Thor Motor Coach Technical Service Bulletin

TSB #	TSB 20-05		
Description/Title:	Fog Light Relay		
Affected Product Line(s):	Certain Model Year 2021 Hurricane & Windsport Motorhomes		
Service Campaign # :	RC000193	Released Date:	7/21/2020
Repair Codes:	Repair: TMCTS80261W	Document Date:	7/21/2020
Time Allowed:	Repair: 0.3	Document Revision:	A

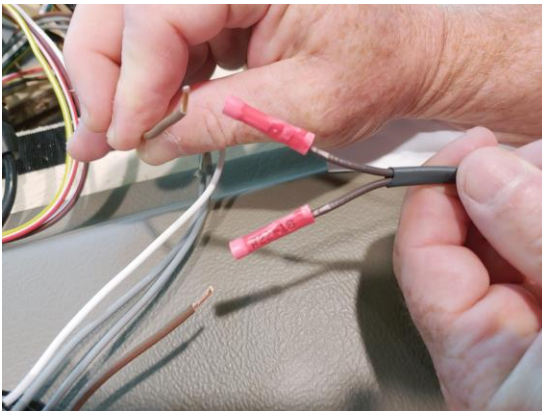
2. Cut Brown wire on relay and strip both ends.

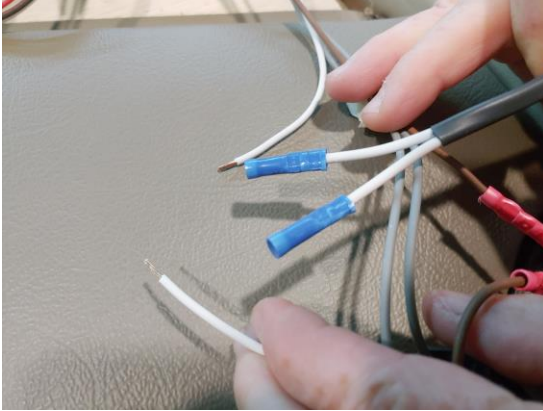
3. Connect the Red ends of the harness to each end of the Brown wire and crimp.
